**SWIMMING POOL TAC
WITHOUT COMMENTS**

***This document created by the Florida Department of Business and
Professional Regulation -
850-487-1824***

TAC: Swimming Pool

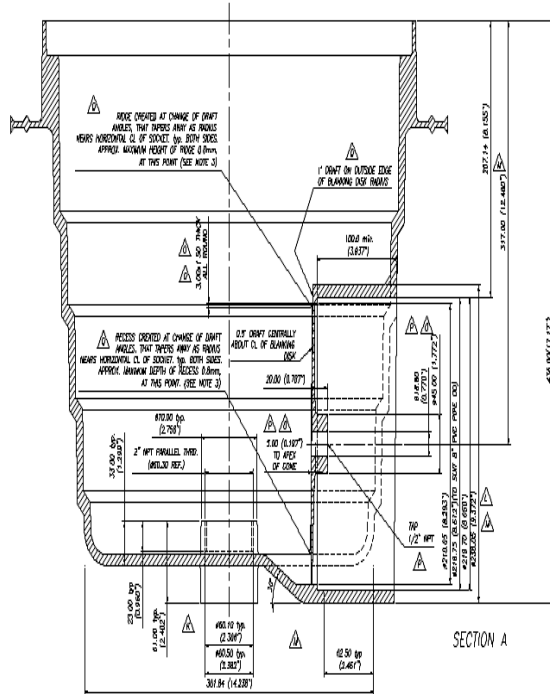
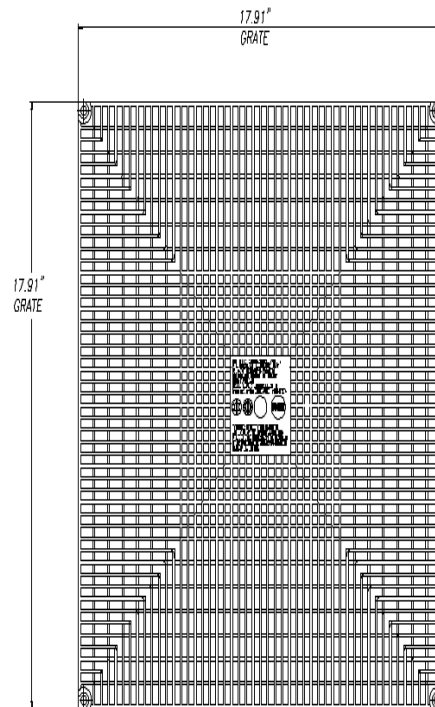
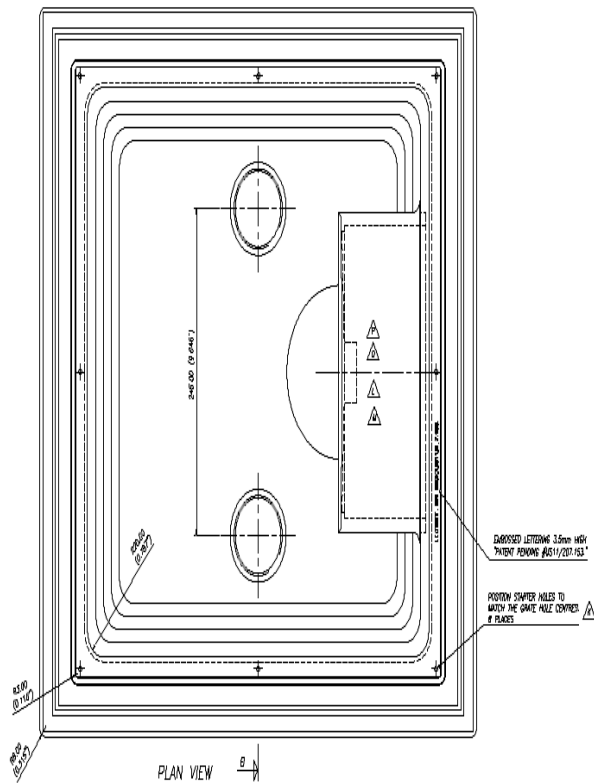
Here the building code conflicts with national standards and current practice from leading drain grate manufacturers. Note the attached drawing. This popular drain grate is stamped with a maximum, national code compliant flow rate of 816 gallons per minute, but only accepts an 8" pipe. In Florida currently, a pool builder can only route about 500 gallons per minute through this drain, legally, because any faster would violate the 3 ft/s rule for pipes. Further, flows above about 570 gallons per minute would violate the 1.5 ft/s rule.

Proponent	Michael Weinbaum	Submitted	1/8/2019	Attachments	No
Comment:					
What I wrote under "rationale" has a math error.					
The 1.5 ft/s rule would actually limit the grate shown in the attached drawing to 855 gallons per minute, not 570 like I wrote. But the ANSI/APSP-16 rating is less, 816 gpm is stamped on the grate. As written, Florida code requires the engineer and the building department official to check three things: the ANSI/APSP-16 flow rate, and the open area, and the pipe connection size, and then do math to figure out which of the three works out to less flow. This seems like unnecessary work in light of how much testing the manufacturers perform to obtain their ANSI/APSP-16 flow rate.

Proponent	Kari Hebrank	Submitted	2/13/2019	Attachments	No
Comment:					
The Florida Swimming Pool Association is OPPOSED to this code modification because it exceeds all other design standards and there are safety concerns with maximum flow velocity.

Proponent	robert vincent	Submitted	2/18/2019	Attachments	No
Comment:					
<p>This Mod will weaken the code for anti-entrapment and would likely violate the federal law for pool suction outlet anti-entrapment which references the national suction outlet standard in the FBC, as does also the Florida Statute at s.514.0315(1). There is no need to eliminate the 1.5 ft/s flow through main drains as all professional designers are familiar with the FBC and the gravity drainage criteria. When a lab using the nationally referenced standard tests a drain grate at 1.4 ft/s or less, this is reflected in published spec sheets of the manufacturer and compiled in a code compliant drain list by the Dept. of Health on the public swimming pool webpage: http://www.floridahealth.gov/environmental-health/swimming-pools/index.html</p> <p>Florida's gravity flow systems to collector tanks, combined with the current maximum flow velocities through main drain gates, suction, gravity and pressure lines has served the citizens of this State well – without a single documented suction entrapment. The issue of direct suction vacuum ports is recognized and a proposed code modification has been submitted to address this issue.</p>
